**23G ECM-100 MAIN & RELAY BOARD UPDATES**

Due to the older design of the 23G ECM-100 circuit boards (PCAs), efforts were made to update the design to allow continued production and spares.  These boards are to be implemented in mid-2016 or when the current V2 version supply is exhausted.  There is no requirement to update unless desired.  Current product will perform as intended without this update.

**Image 1 – SW1/2 Locations**

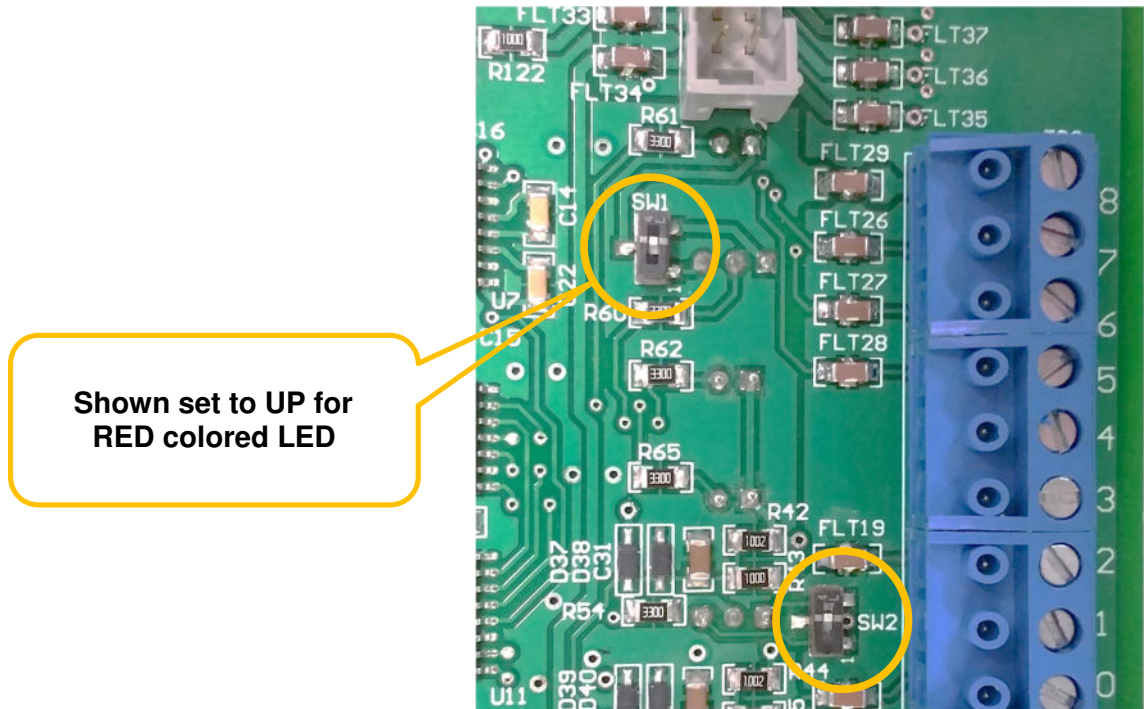
There were two changes made that users should be aware of.
1. Dual color Red/Yellow LEDs[i].
2. USB computer and printer connections

The dual color LEDs allow users who do not want red indicators (Alarm and Permeate Divert) to use a yellow indicator.  This is changed on the back of the Main Board by changing the SW1 and SW2 switches located near the top right from the up position to the down position (see Image 1 at end of this document).

**Shown set to UP for RED colored LED**
